BLASTCOAT-RESEARCH PRODUCTS

SUBDIVISION

APPLICATION NUMBER 7 DATE July 19, 2018

DETAIL SITE PLAN

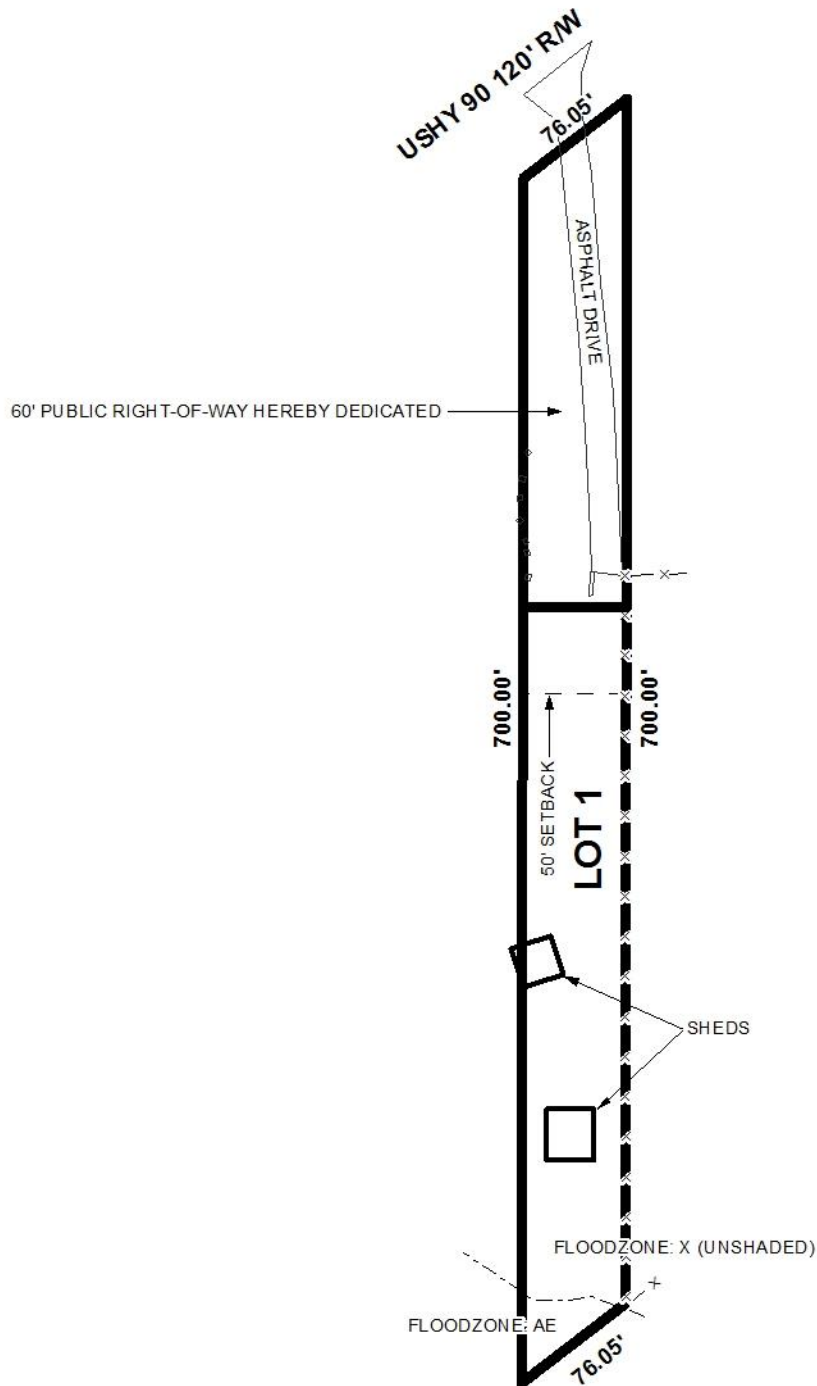
The proposed lot has frontage along U.S. Highway 90, an ALDOT-maintained major street requiring a 250' right-of-way per the recently adopted Major Street Plan. The preliminary plat illustrates a 120' right-of-way width along with a note dedicating a 60'-wide, 249'-long strip of right-of-way, far exceeding the minimum right-of-way requirement along U.S. Highway 90. Staff verified the applicant's intent to dedicate such right-of-way, thus no additional dedication is required, but the plat should be revised to indicate the minimum 250' right-of-way requirement along U.S. Highway 90.

The lot exceeds the maximum width-to-depth ratio of the Subdivision Regulations. Similar lot designs are common within the vicinity of the subject site, but none of these have been approved by the Planning Commission. Nevertheless, it is reasonable that, given the character of the surrounding area, a waiver of Section of V.D.3. of the Subdivision Regulations may be appropriate.

The lot meets the minimum size requirements for lots served by public water and individual septic systems, but its size is provided only in square-feet and not acres. Revision of the plat to indicate the size of the lot in both square-feet and acres should be required, if approved; or, provision of a table on the Final Plat providing the same information may suffice.

A minimum building setback line is illustrated 50-feet from the extensive right-of-way proposed to be dedicated, and exceeds the 25' minimum building setback line requirement of the

Subdivision Regulations. As such, retention of at least a 25' minimum building setback line on the Final Plat should be required, if approved.

As a means of access management, a note should be placed on the Final Plat stating that the lot is limited to one (1) curb cut, with any changes in its size, location, or design to be approved by ALDOT (as necessary) and Mobile County Engineering, and conform to AASHTO standards.

The site is located in the County, thus any lots which are developed commercially and adjoin residentially developed property must provide a buffer in compliance with Section V.A.8. of the Subdivision Regulations. A note regarding this requirement should appear on the Final Plat, if approved.

A portion of the lot is located within the flood plain. As such, wetlands may occur on the site and may therefore be environmentally sensitive. Approval of applicable federal, state and local agencies may be required prior to development of the site.

Finally, the site will have to comply with the City of Mobile storm water and flood control ordinances. A note stating *"Must comply with the Mobile County Flood Damage Prevention Ordinance. Development shall be designed to comply with the storm water detention and drainage facility requirements of the City of Mobile storm water and flood control ordinances, and requiring submission of certification from a licensed engineer certifying that the design complies with the storm water detention and drainage facility requirements of the City of Mobile storm water and flood control ordinances prior to the issuance of any permits."* should be placed on the Final Plat, if approved.

With a waiver of Section V.D.3. the proposed plat meets the minimum requirements of the Subdivision Regulations and is recommended for Tentative Approval, subject to the following conditions:

- 1) revision of the plat to indicate the minimum 250' right-of-way requirement along U.S. Highway 90;
- 2) retention of the dedication of the 16,390± square-foot area for right-of-way;

- 3) revision of the plat to indicate the size of the lot in both square-feet and acres, or provision of a table on the Final Plat providing the same information;

- 4) retention of at least a 25' minimum building setback line on the Final Plat;
- 5) placement of a note on the Final Plat stating that the lot is limited to one (1) curb cut, with any changes in its size, location, or design to be approved by ALDOT (as necessary) and Mobile County Engineering, and conform to AASHTO standards;

- 6) placement of a note on the Final Plat stating that any lots which are developed commercially and adjoin residentially developed property must provide a buffer, in compliance with Section V.A.8. of the Subdivision Regulations;

- 7) placement of a note on the Final Plat to comply with the Mobile County storm water and flood control ordinances: *"Must comply with the Mobile County Flood Damage Prevention Ordinance. Development shall be designed to comply with the storm water detention and drainage facility requirements of the City of Mobile storm water and flood control ordinances, and requiring submission of certification from a licensed engineer certifying that the design complies with the storm water detention and drainage facility*

requirements of the City of Mobile storm water and flood control ordinances prior to the issuance of any permits.”; and,

- 8) compliance with Fire Department comments: *“Projects outside the City Limits of Mobile, yet within the Planning Commission Jurisdiction fall under the State or County Fire Code (2012 IFC).”*
